LIGO- T080091-00-K

ADVANCED LIGO

Proposal for baseline change from ribbons to fibres in
AdvLIGO test mass suspension monolithic
stage

Figure 1: Optimization of total loss after dissipation dilution for 10:1 ribbons (surface+bulk, thermoelastic, total; $t_{\text{opt}} = 0.224$ mm; min. loss = 4.68×10^{-11})

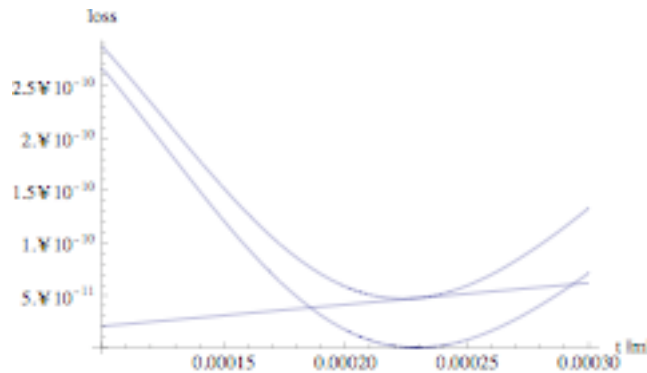
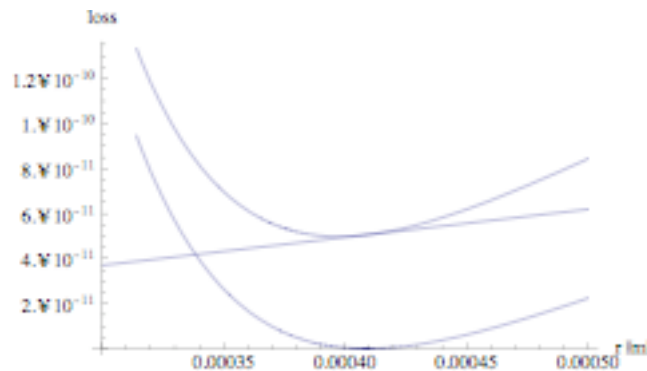
The net result is that the total loss with optimized ribbons is about 5.3 times better than the baseline ribbons (2.48×10^{-10}), but only about 6.5% better than optimized fibres. The frequency dependence of the net loss and the improvement relative to a naïve optimization that merely zeroes the thermoelastic loss is shown for the optimized ribbons in Figure 3. The thermal noise for the baseline ribbons and the optimized ribbons and fibres (as calculated using Mark Barton’s Mathematica model) is shown in Figure 4.

Given that fibres give nearly as much margin on the requirement as ribbons and have certain practical advantages (see below), this suggests that the decision to go with ribbons should be reconsidered.
